# FACPAC Contract Change Order Supplemental Information Form (Ref# 57717)

Tier 1 Project: Estill Springs Elementary Phase 2 Renovations & Addition - ESSER III  
BG Number: 22-207 District: Estill County (HB678)  
Status: Active Phase: Project Initiation (View Checklist)

**CHANGE ORDER NUMBER:** 11-02  
**INITIATION DATE:** 3/27/2023

**PR # 11 Underslab Sewer Repairs @ Restroom**

**MODEL 840/841/842**

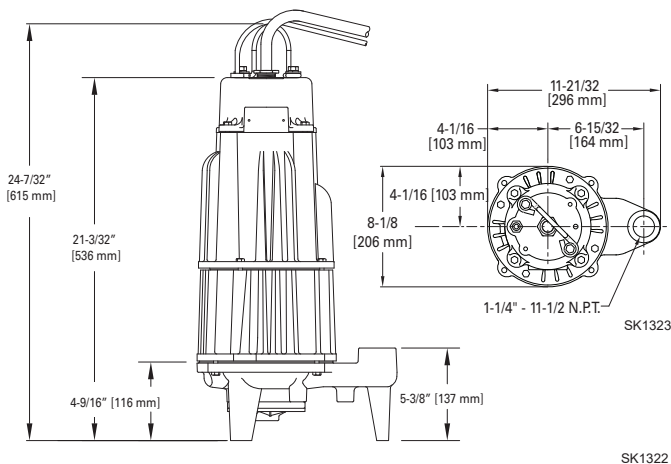
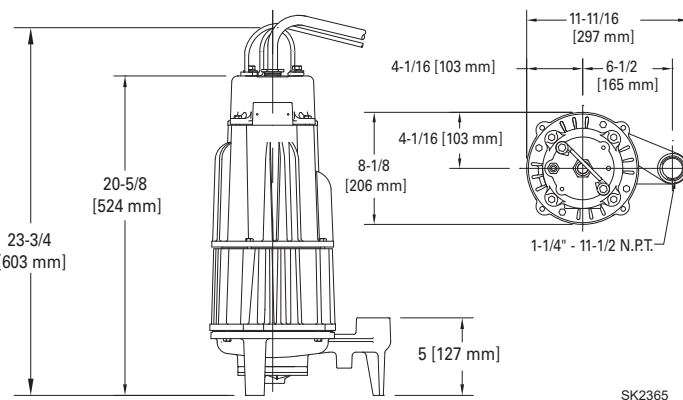
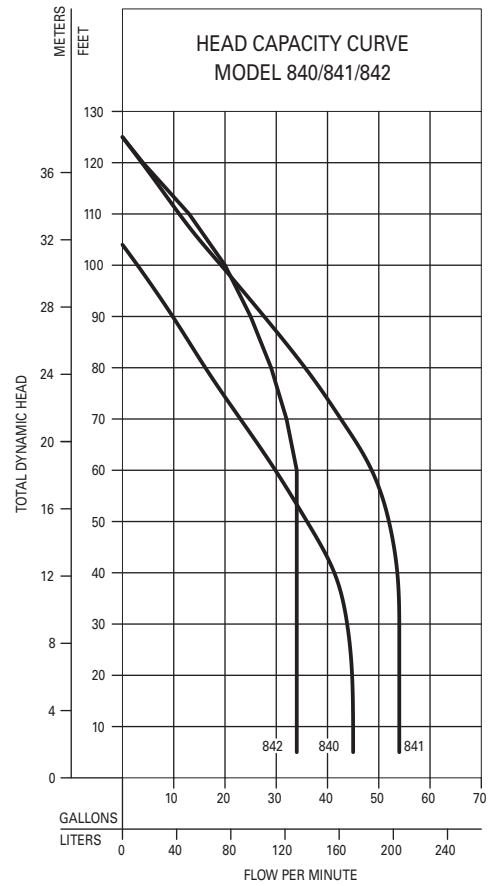
2. Provide pricing to provide and install duplex grinder pump with exterior basin and control panel installed outside the building in the sanitary line downstream of the connection of the two new classrooms. See attached selection: Zoeller Shark Series – Pump Model 840 with 45 GPM at 10' of head. Duplex control panel with NEMA 4X enclosure, audible and visual high water alarms, starting, control, and alarm circuits, circuit breaker and rated motor contactor, alternating circuit, high water alarm light with flasher, HOA switches and pilot lights. 36"W x 60"D Fiberglass outdoor basin with anti-flotation ring, rail disconnect system, inlet and discharge pipe seals, float tree with floats. Route electrical circuit from existing panel in kitchen – field verify panel location and circuit space. Pipe discharge under existing restroom to main in corridor separate from line serving the restroom fixtures. (See attached)
